CUSTOMER TECHNICAL MEMO # 310

Subject: HE320 TO ME8 Transition + MFE55 Release

Date: 13/12/2017

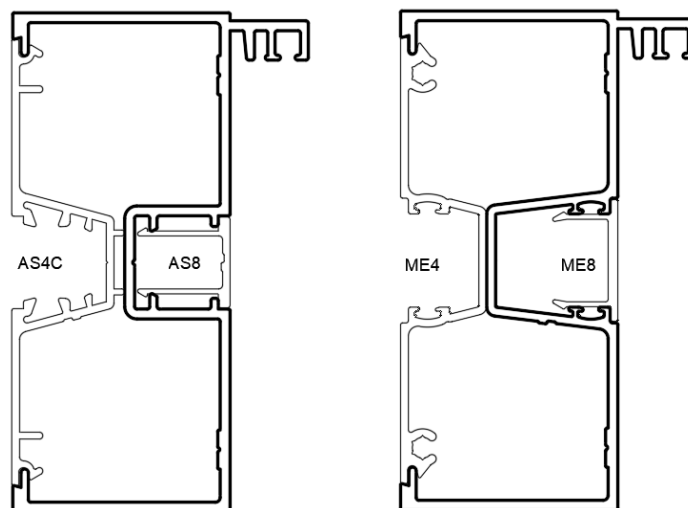
During the development of McArthur Evo 19mm pocket upgrade, the ME8 pocket filler was created as an improvement over HE320 which will now be made obsolete.

ME8 has an improved 30 degree lead in, and has been widened to 18.8mm to tighten up the fitment in the pocket as per below.
